LOT 27

SITING AND GRADING PLAN

GOLDPARK HOMES - 221081  
PINE VALLEY PH2 - VAUGHAN, ON

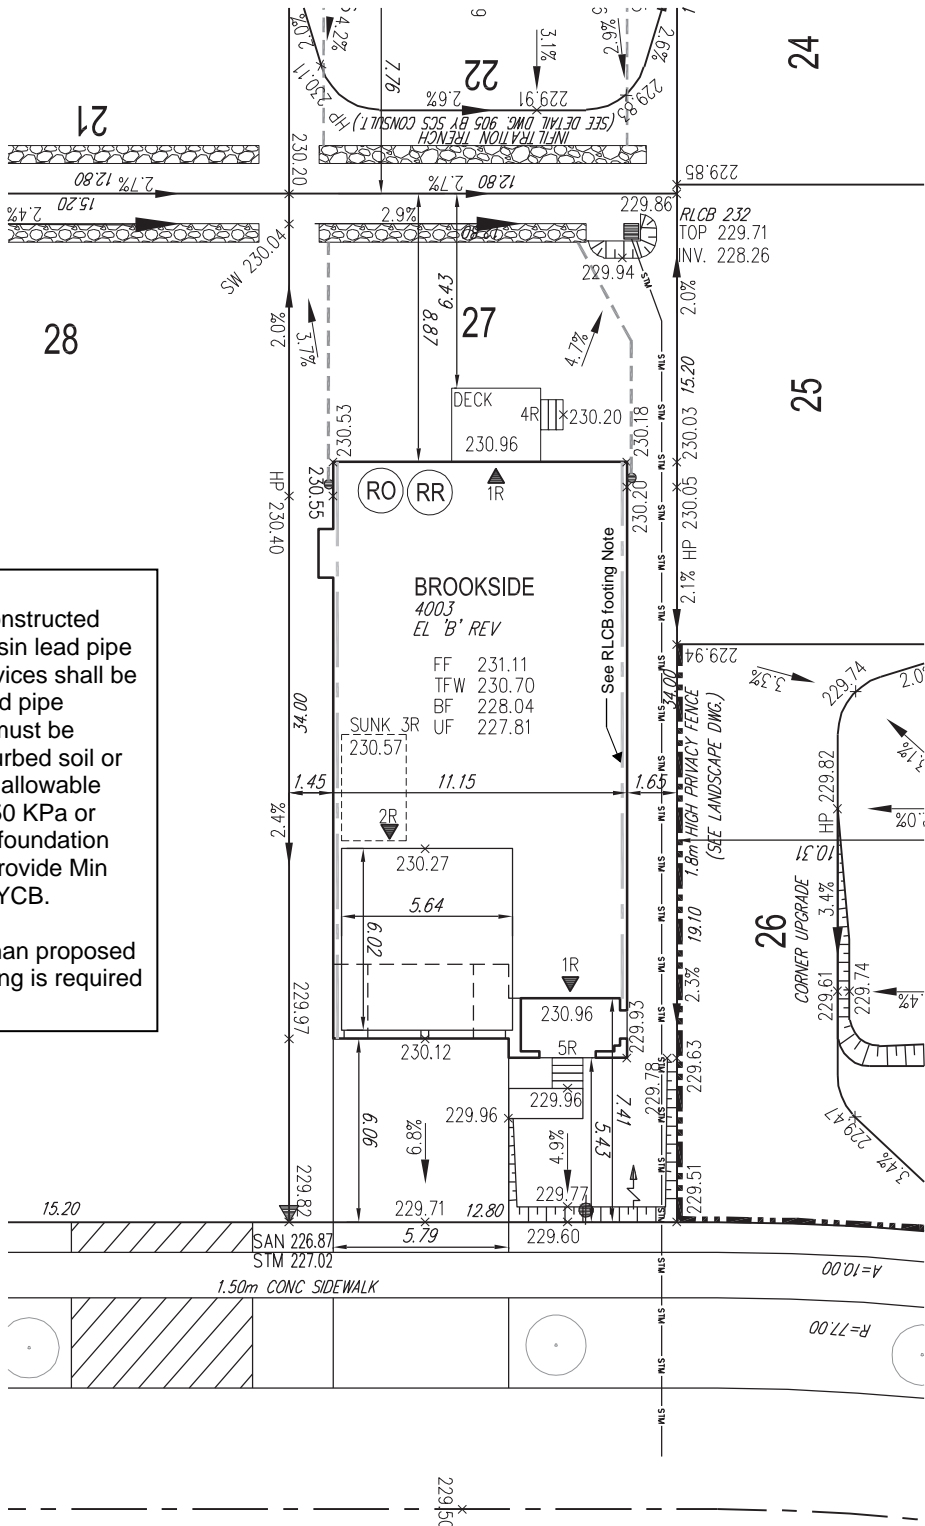
RLCB footing Note:  
2.2.3.1 (x) Footings constructed adjacent to a catch basin lead pipe or other municipal services shall be installed below the lead pipe excavation. Footings must be constructed on undisturbed soil or engineered fill with an allowable bearing pressure of 150 KPa or greater depending on foundation design loads. Please provide Min USF required along RYCB.

RLCB lead is higher than proposed UF. no extending footing is required for this lot
